Lower St. Vrain Watershed Phase 2 Hydrologic Evaluation Post September 2013 Flood Event

**Colorado Department of Transportation
Region 4 Flood Recovery Office**

July 2015

Figure ES-2. Peak Discharge Profiles for St. Vrain Creek and North St. Vrain Creek

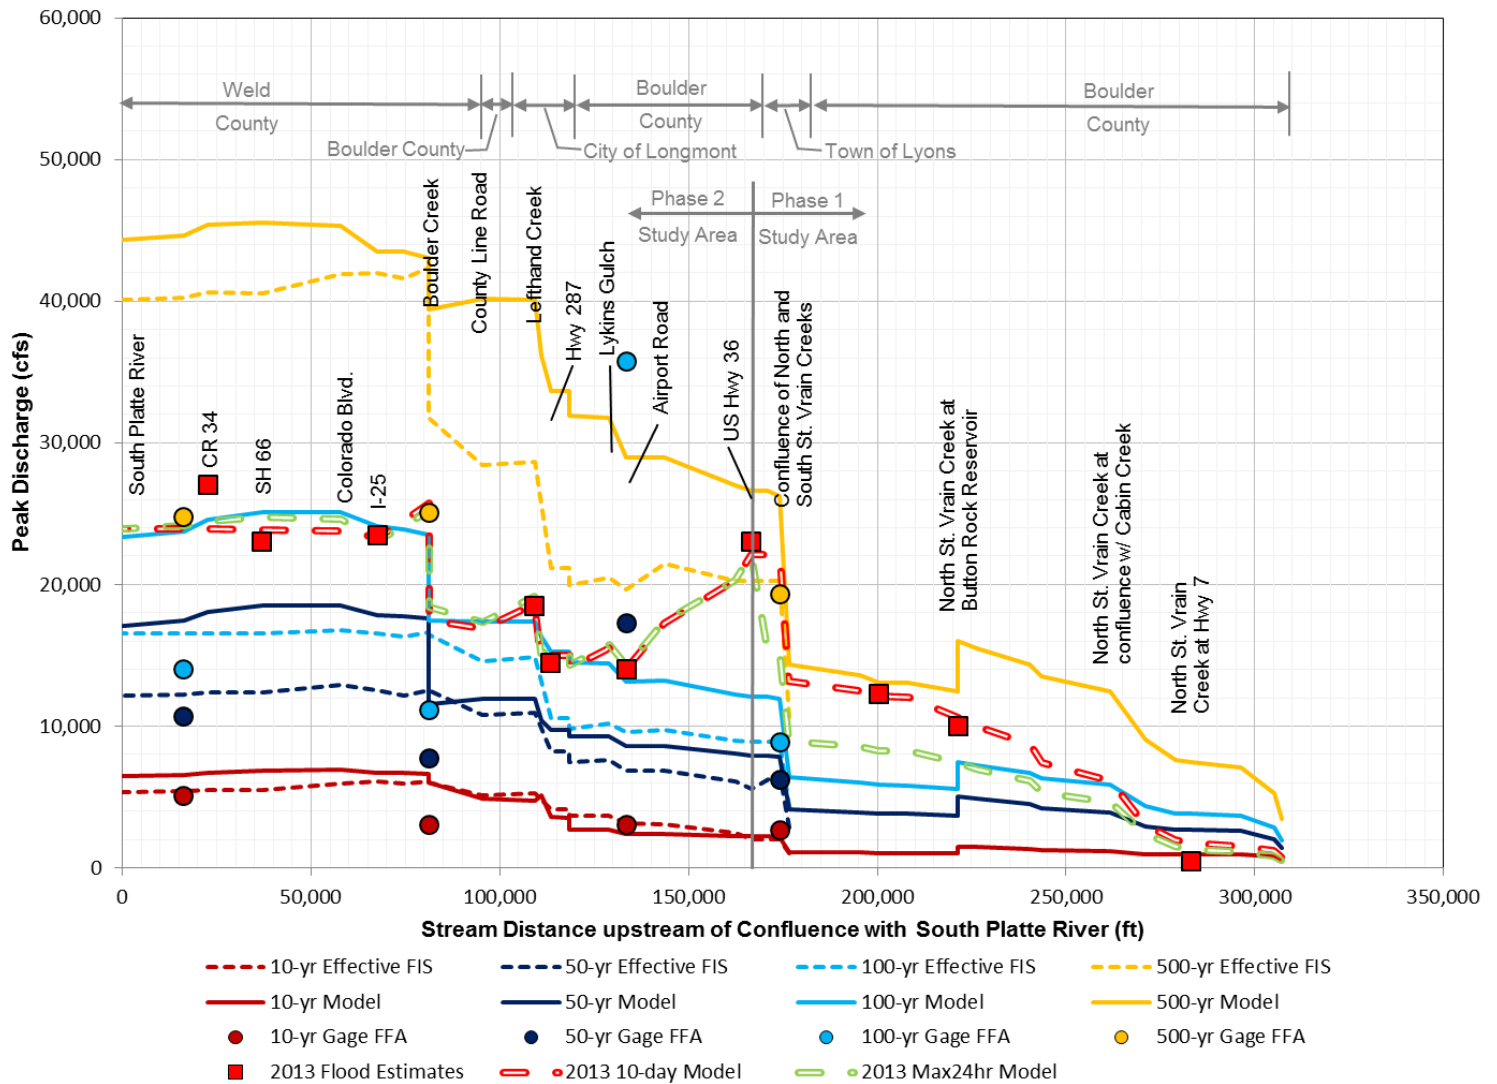
3. Figure ES-2 may be a little too busy to "squeeze" into such a small space. Same note for Figures 4 and 5. It seems like perhaps these figures could have their own page? They're very good graphical representations, but can be hard to decipher if too small.
The small versions of the figures were embedded in the report for the reader's convenience so they don't have to turn to a special section for figures or to the appendices to follow along with the discussion. Larger versions of the figures are included in Appendices D.6 and D.7. Text has been added to the relevant sections in the report to bring this to the reader's attention and to direct them to the appendices if they wish to look at the larger versions for more detail.

Figure 1

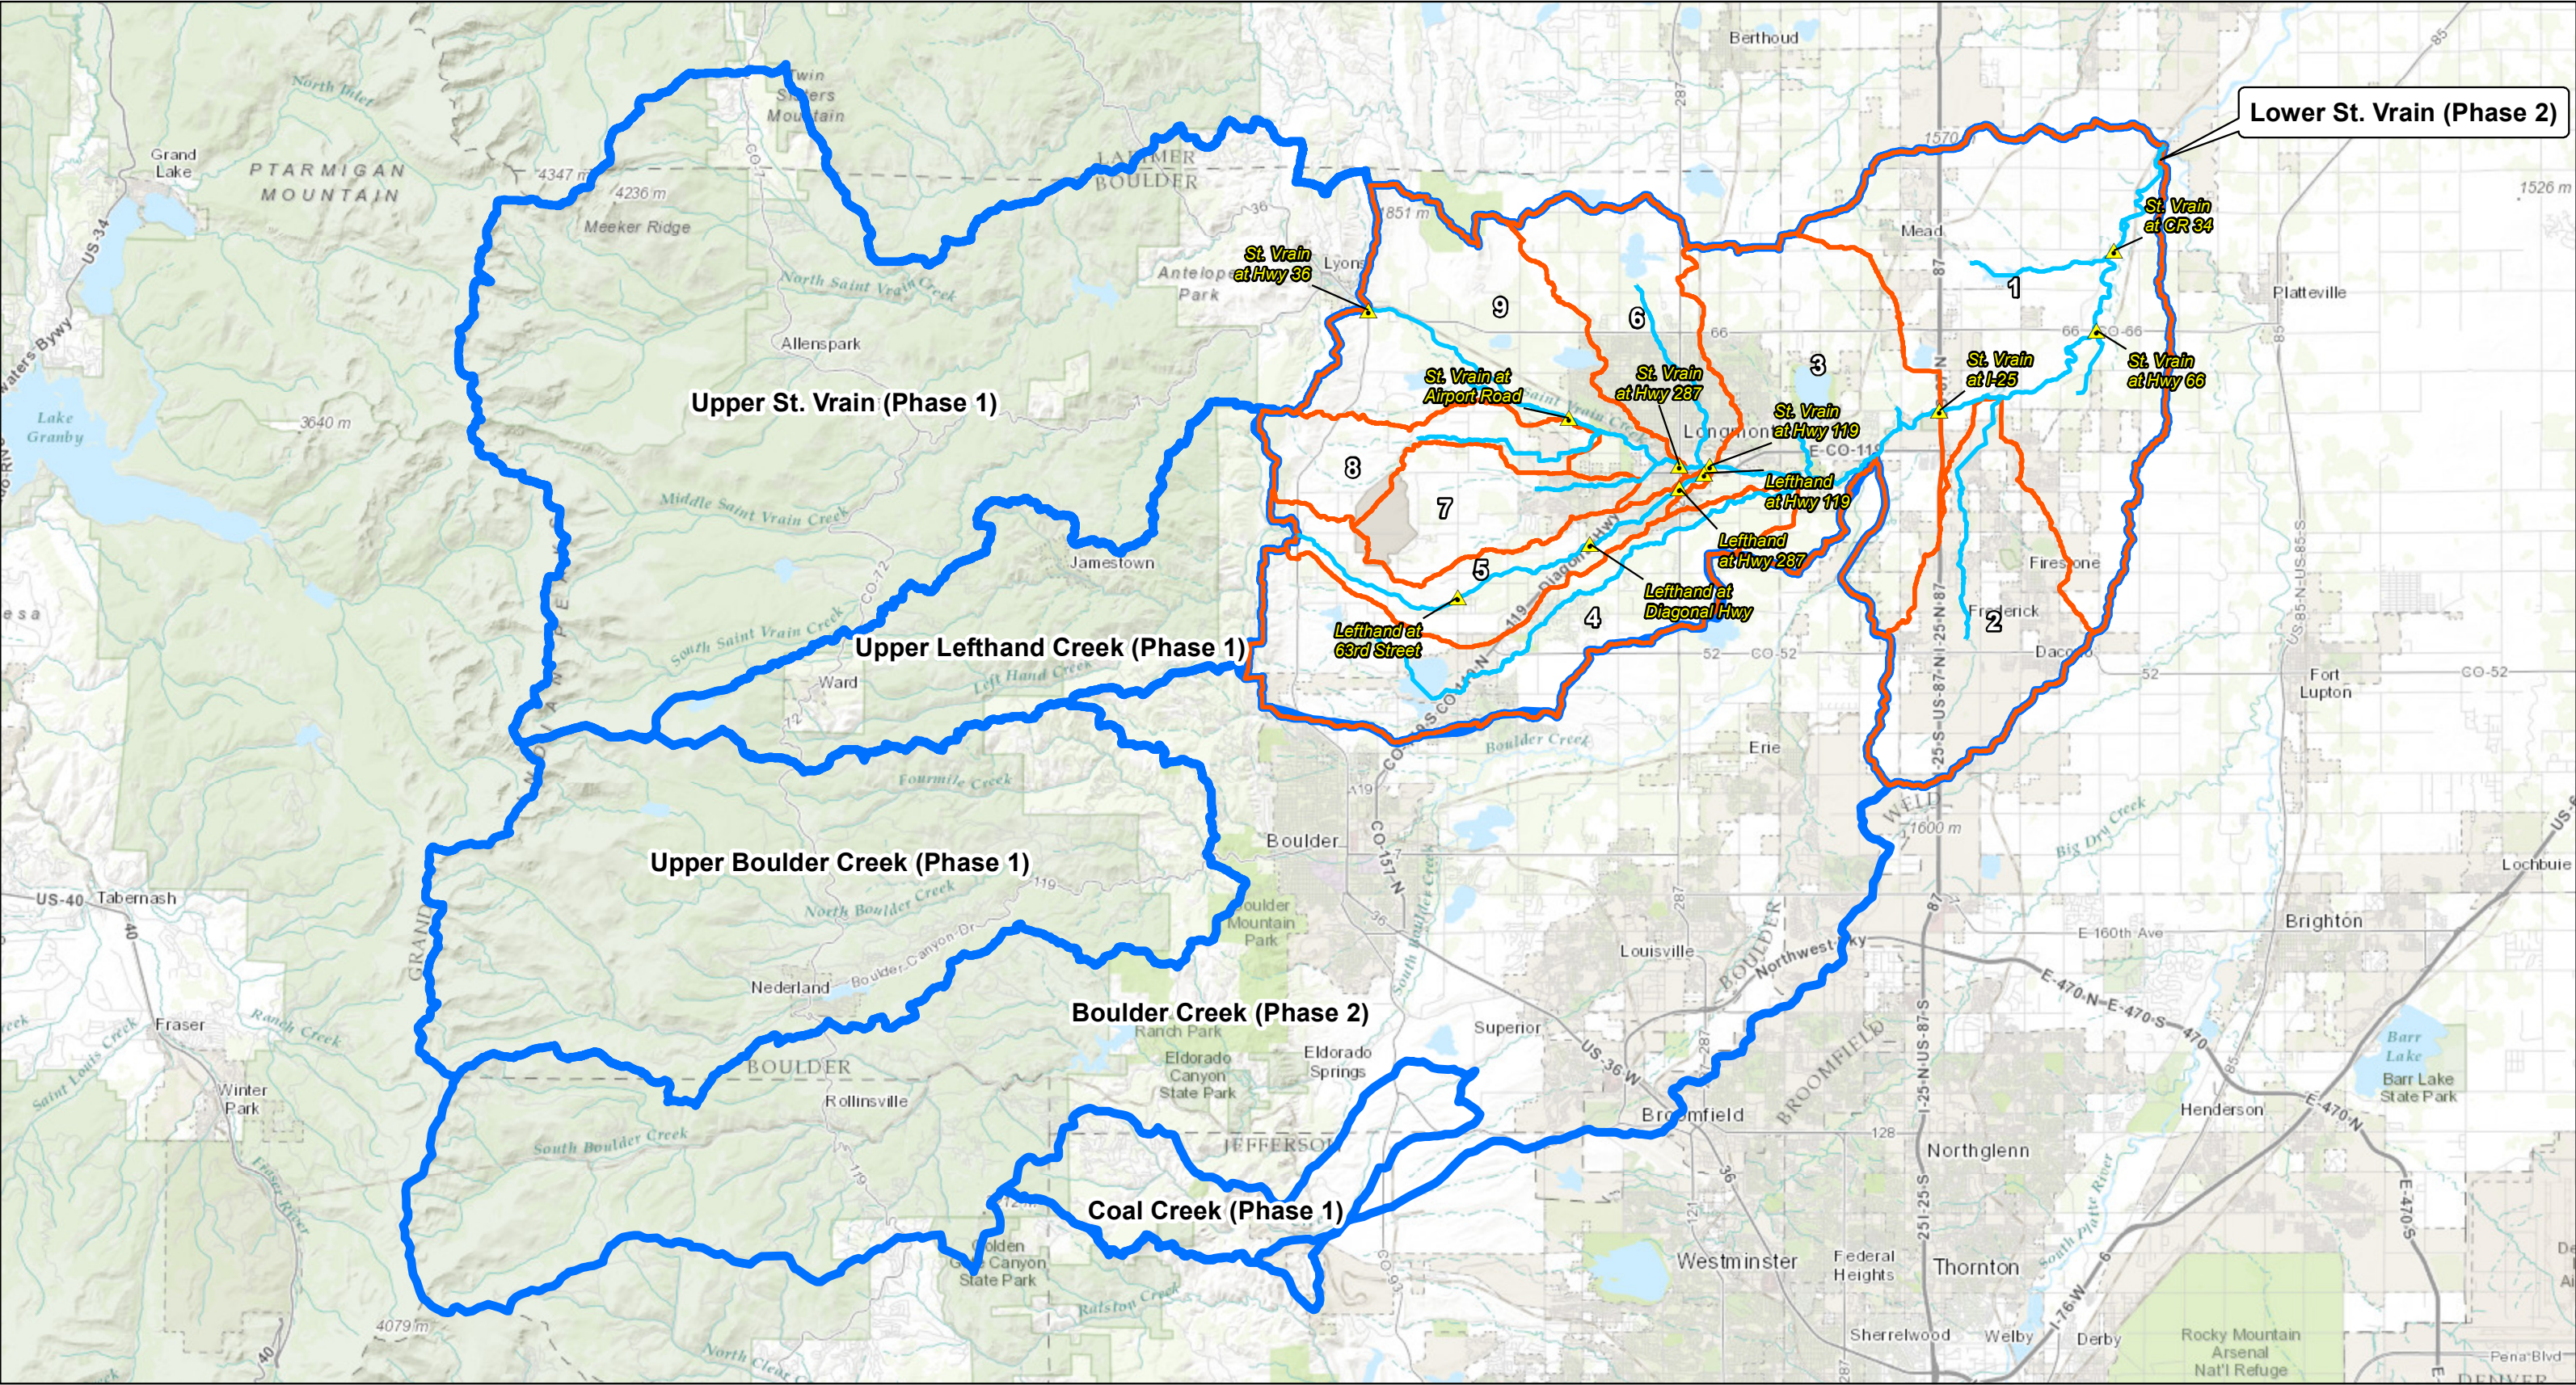
3. Page 5 – The Phase 2 area in Figure 1 should be enlarged or shown in a separate figure to better illustrate the Phase 2 watershed area. A Figure 1 caption needs to be added to the figure. Also note that the larger Phase 2 watershed area map shown in Appendix D is actually for the LowerBig Thompson Watershed and not the Lower St. Vrain Creek watershed. This needs to be revised.

A Figure 1 caption was added to Figure 1 in the report section. The correct figure for St. Vrain Creek was added to Appendix D as Figure D.1. The Phase 2 area is shown on Figure D.1 in more detail than on Figure 1.
